Reference: U.S. Oil Sands (USOS) PR Spring Mine Response to Initial Review – List of Pages

Re: **M/047/0090 - U.S. Oil Sands, Inc., PR Spring Mine – Response to Initial Review of Revised Notice of Intention (NOI) to Commence Large Mining Operations**

**Response to INITIAL REVIEW OF NOTICE OF INTENTION
TO COMMENCE LARGE MINING OPERATIONS**

**U.S. Oil Sands
PR Spring Mine**

Secondary Containment

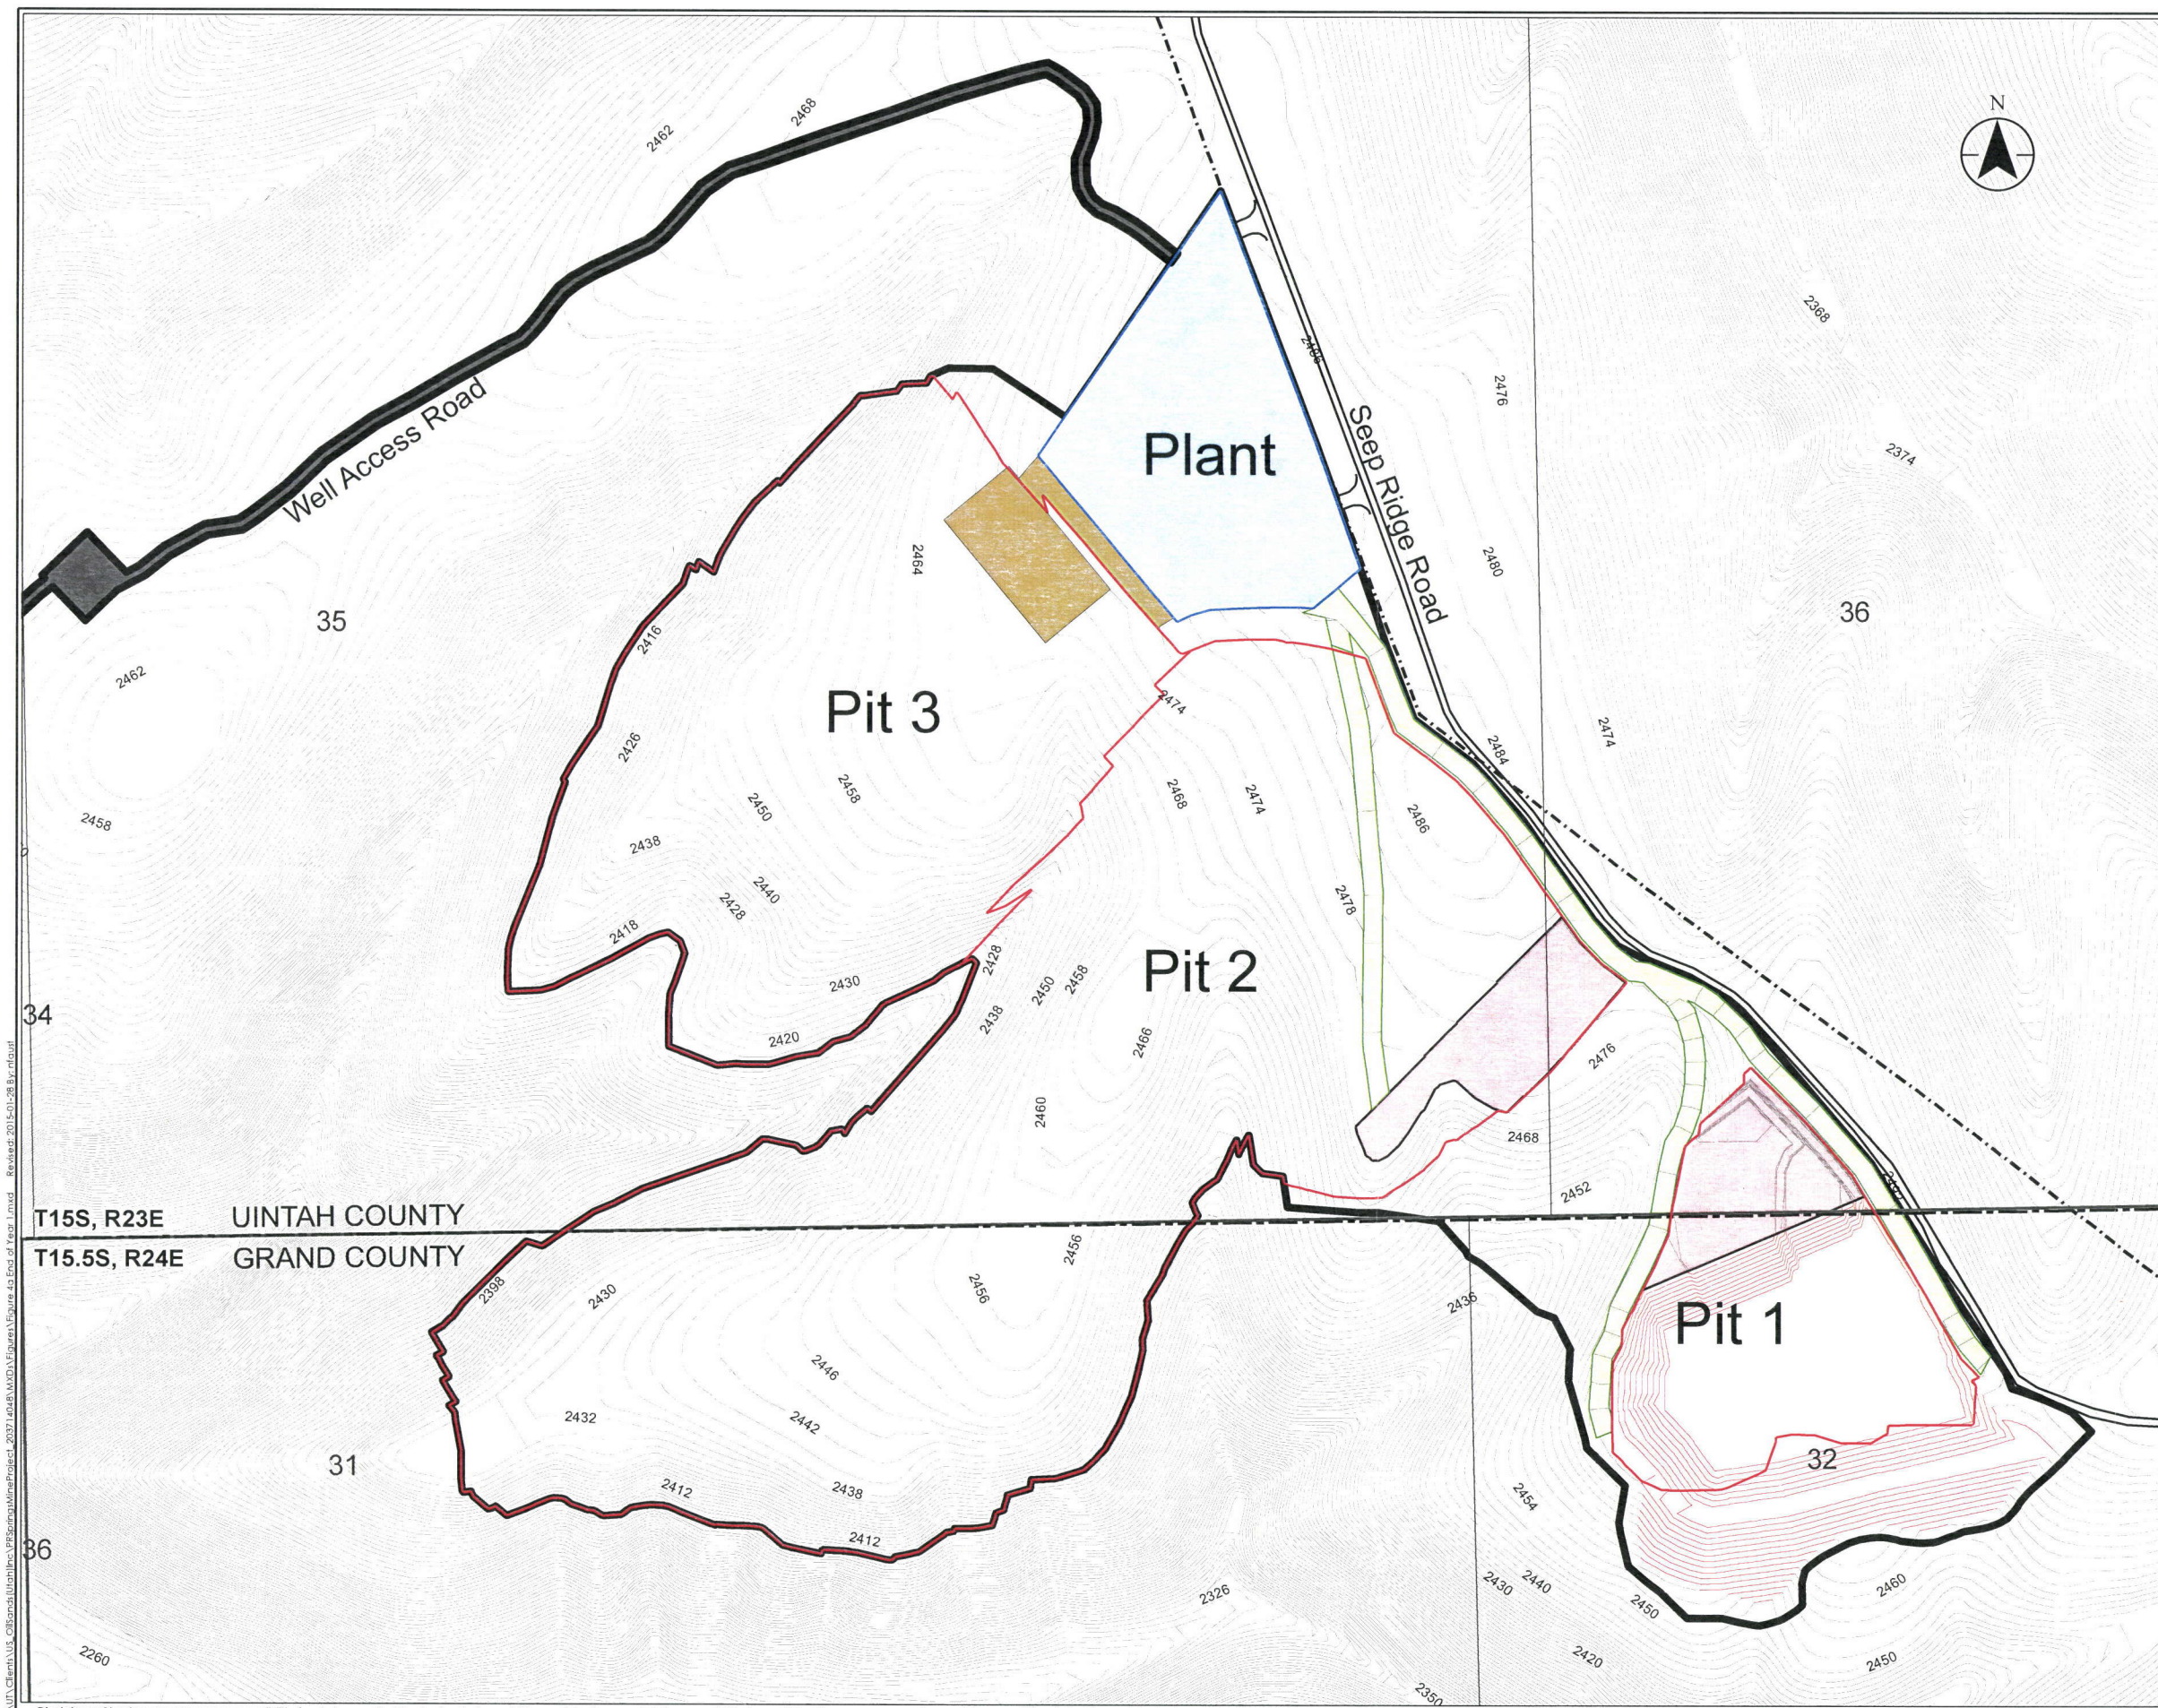
Com ment #	Sheet/Page/ Map/Table #	Comments	Initia ls	Revie w Actio n
10	Omission	Include areas that will be lined and label areas where secondary containment is needed. Please also include labels on the figures of clay lined or HDPE liners. Figure 3a has been added. Please see response to Comment #19.	lah

End of Year 4

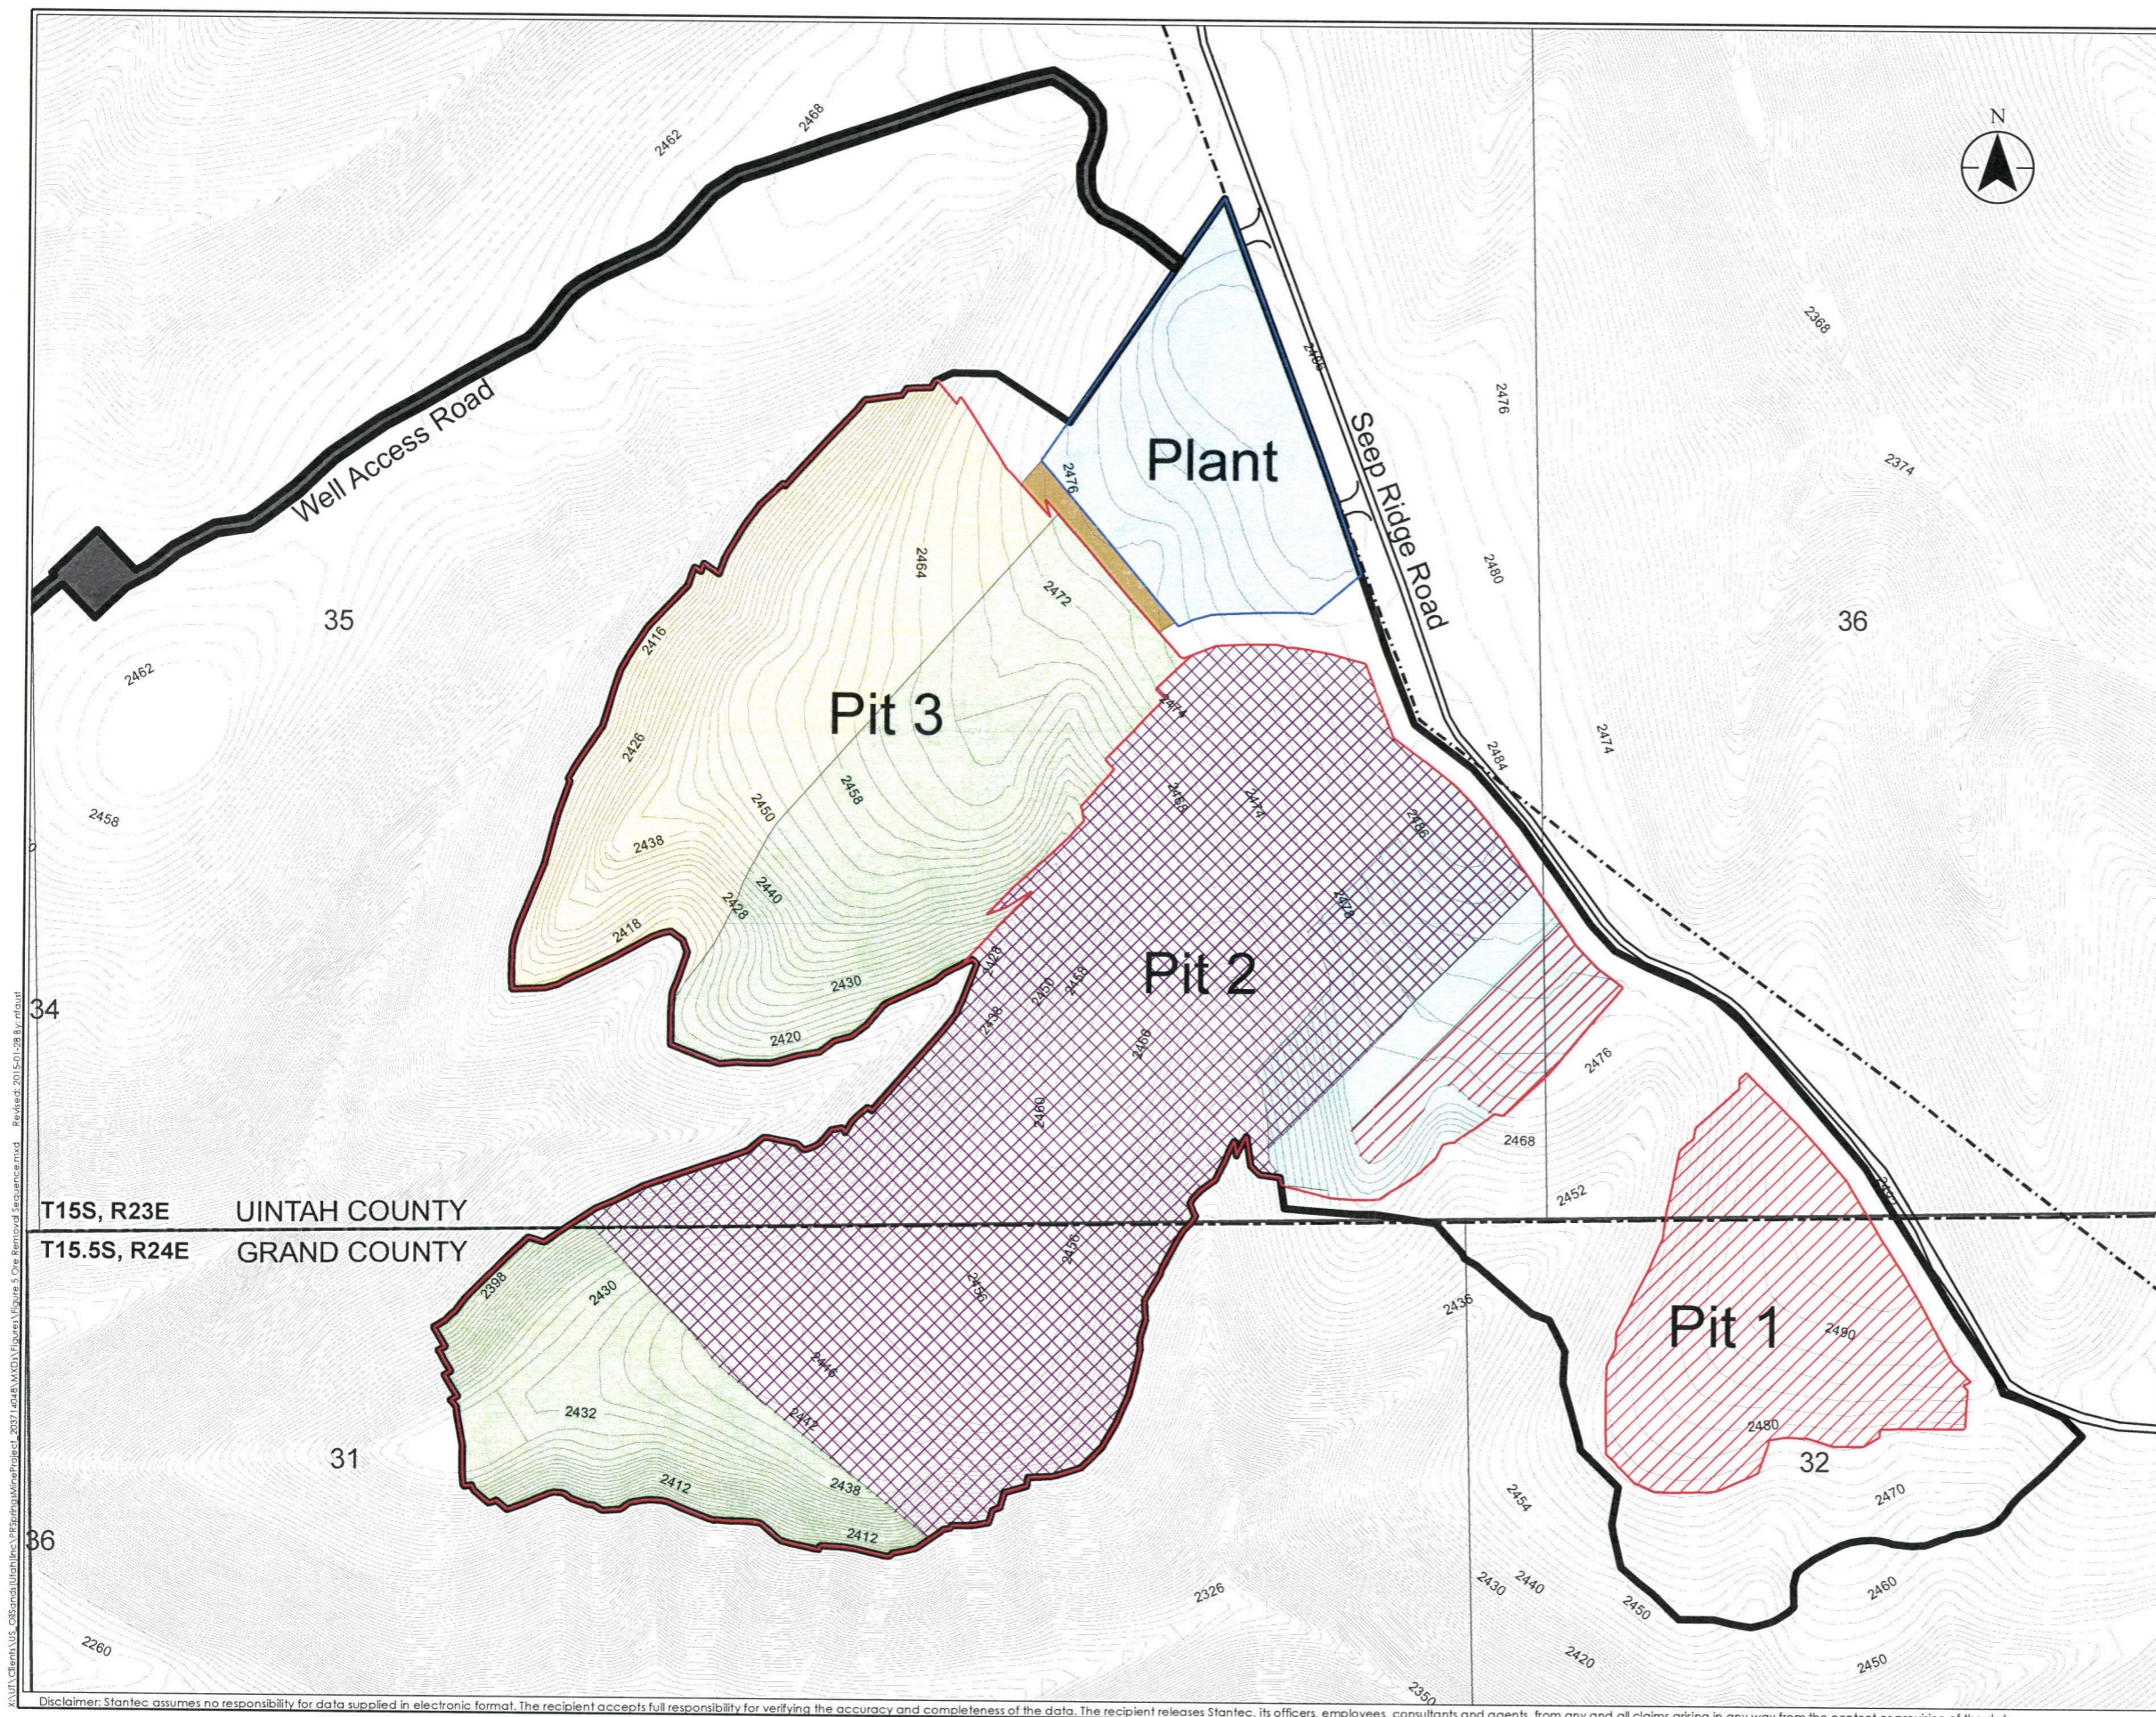
Com ment #	Sheet/Page/ Map/Table #	Comments	Initia ls	Revie w Actio n
11	Figure 4d	Please include reclamation maps up through the end of year 6, since that is what the text states will be the completion time for the Phase I activities. The Phase 1 activities extend through year 5, as noted in the Notice text. Year 6 has been removed from Table 2. The reclamation map is Figure 11.	aa	
12	Figure 7	Please be more specific about which sediment control features will be used at the bottom of the pit slopes instead of labeling the areas SED BMP. Sediment control features including straw wattles, erosion control matting, and rip/rap have been added to Figure 7.	aa	
13	Figure 8	Please put a strike and dip symbol on the map which is consistent with the text. Use USGS standards, i.e. add to legend, use stand symbol, and place symbol at the outcrop location. The strike and dip symbol has been added to Figure 8.	lah
